1199 Panigale Safety Upgrades  
Models: MY 2012 and MY 2013 Panigale (All Versions)  
**Recall Bulletin RCL-12-006**

Date: Tuesday, August 7<sup>th</sup>, 2012  
To: Dealer Principal, Service Manager, North American Dealer Network  
From: Austin Gray, Technical Director; Jonathan LaForte, Technical Manager

***Description of the technical problem:***

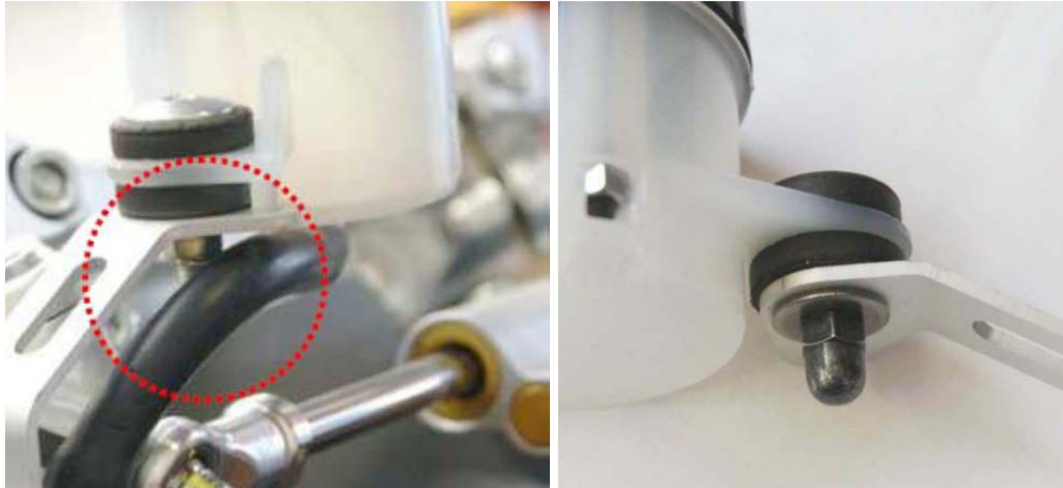
- C) **STEERING DAMPER RETAINING SCREWS** (all versions): The two steering damper retaining screws might loosen from their original tightening torque. It is necessary to re-tighten the screws and properly apply the specified threadlocker.

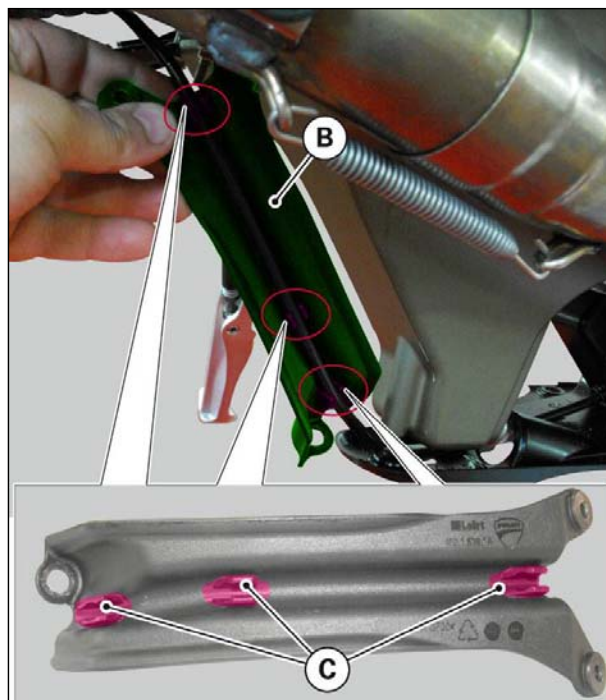
- 8) Release the exhaust butterfly valve cable from the clips of the *exhaust butterfly valve Bowden cable support (A)* and remove the latter.

- 9) Install the new *exhaust butterfly valve Bowden cable support (B)* part no. 46015393A and engage the cable inside the *three clips (C)*.

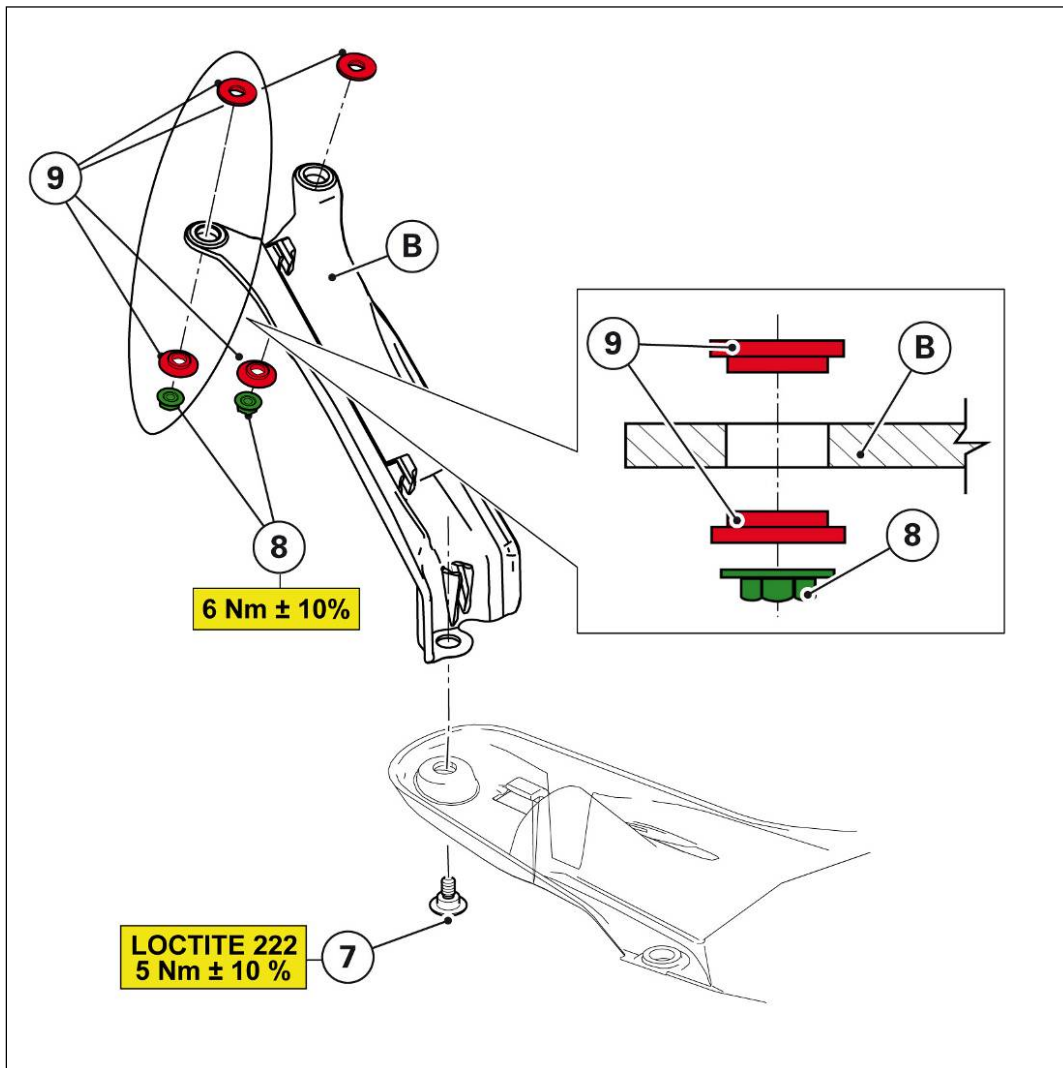
- 10) Fit the new exhaust butterfly valve Bowden cable support (B) part no.46015393A and tighten the **bottom screw (7)** to **5 Nm  $\pm$  10%** after applying **LOCTITE 222** , then tighten the **two top nuts (8)** to **6 Nm  $\pm$  10%**.

Fit the four **spacers (9)** correctly, as shown below.

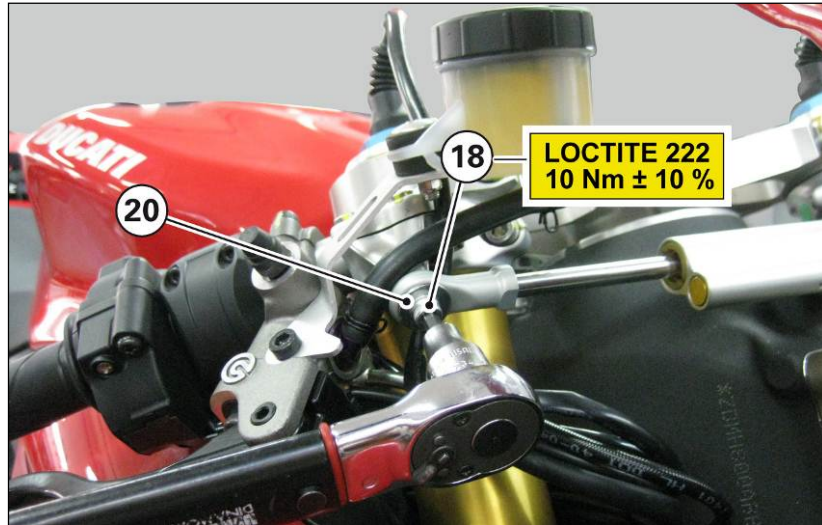
- 3) Remove the **screw (18)** retaining the **steering damper (19)** to the right-hand handlebar, remove any trace of threadlocker and thoroughly degrease the surface.
- 4) Start the **screw (18)** with **washer (20)** in-between.

5) Tighten the *screw (18)* with LOCTITE 222 to 10 Nm ± 10%.

*Washer (20)* must be installed only on S versions, i.e., where an Ohlins steering damper is fitted. The washer must NOT be installed on BASE versions equipped with SACHS steering damper.

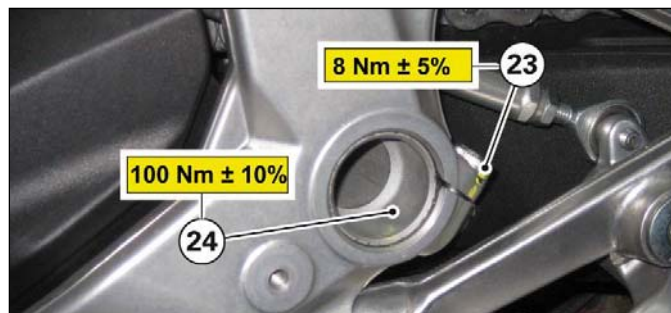
- 1) Loosen the *screw (21)* from clamp on RIGHT-hand swinging arm shaft.
- 2) Loosen the *RIGHT-hand swinging arm shaft (22)* by 180° without removing it.
- 3) Tighten *RIGHT-hand swinging arm shaft (22)* to 100 Nm ± 10%.
- 4) Tighten clamp *screw (21)* to 8 Nm ± 5%.

- 5) Slacken the *screw (23)* from clamp on LEFT-hand swinging arm shaft.
- 6) Loosen the *LEFT-hand swinging arm shaft (24)* by 180° without removing it.
- 7) Tighten *LEFT-hand swinging arm shaft (24)* to 100 Nm ± 10%.
- 8) Tighten clamp *screw (23)* to 8 Nm ± 5%.

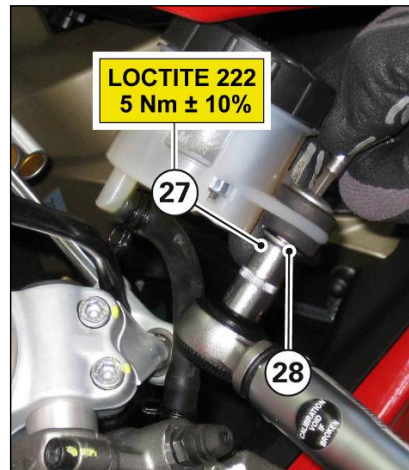
Instructions for replacing *Cap nut M5 DIN1587-KL6 Galvanized black (Ref. no. 3 Page 4)* and add a *washer P.5X15X1.5 UNI6593SS (All versions) Ref. no. 4 Page 4.*

- 2) Start the new *cap nut (27)* and add the *washer (28)*. Tighten the *cap nut (27)* with LOCTITE 222 to 5 Nm ± 10%.
